City of Mississauga Department Comments

Date Finalized: 2021-11-17	File(s): A491.21 Ward: 1
To: Committee of Adjustment	
From: Committee of Adjustment Coordinator	Meeting date:2021-11-25 1:00:00 PM

The applicant requests the Committee to approve a minor variance to allow the construction of an addition proposing:

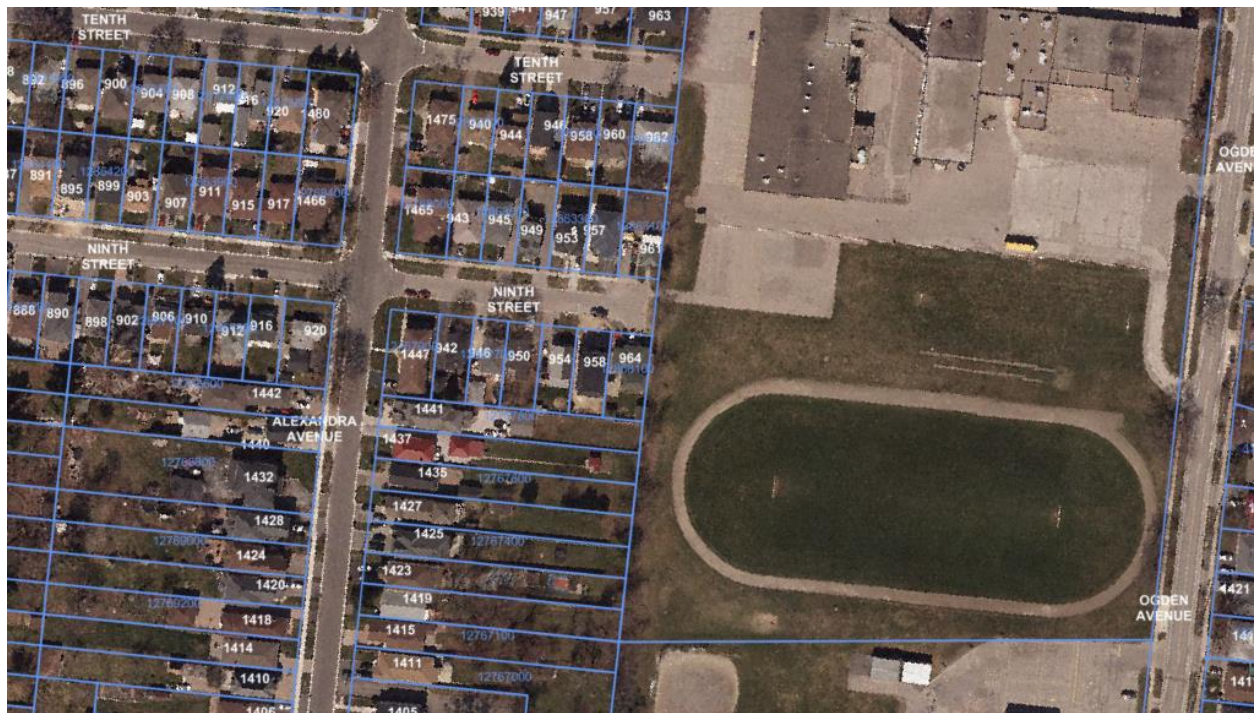
Enclosed for Committee's information please find a photo depicting the existing property. We draw attention to the widened driveway and asphalt ramp that has been placed along the municipal raised curb along Ninth Street. Should Committee see merit in this application, we would request that the widened driveway area within the municipal boulevard be reinstated with topsoil and sod and that the asphalt ramp that has been placed along the barrier curb be removed.

Should Committee see merit in this application, we would request that the widened driveway area within the municipal boulevard be reinstated with topsoil and sod and that the asphalt ramp that has been placed along the barrier curb be removed.
